CASA Ref: F17/6849-18

DPHI ref: (DA25/5067) Email Thu 1/05/2025 12:24 PM

### RURAL SUPPLIES BUILDING, MOREE (DA25/5067: CASA COMMENTS

CASA has reviewed the documentation for the Rural Supplies Building, Moree (DA25/5067).

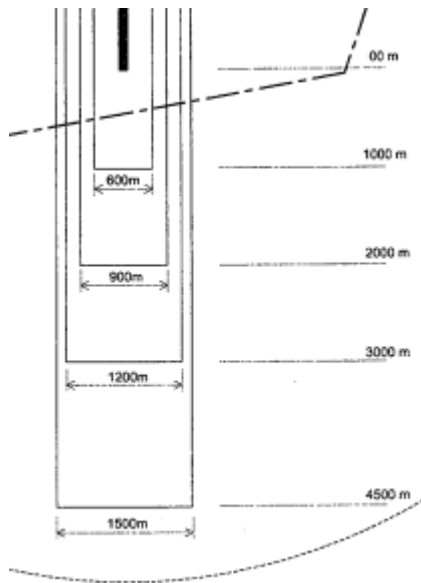
It is expected that there would be more serious bird attractors in the vicinity; for example drains, specific grasses, trees, etc. However, bird (especially) and animal attractors should be avoided.

Rubbish should be stored in closed containers.

Avoid bird perching opportunities where practicable.

If they sell bird feed, it should be packaged.
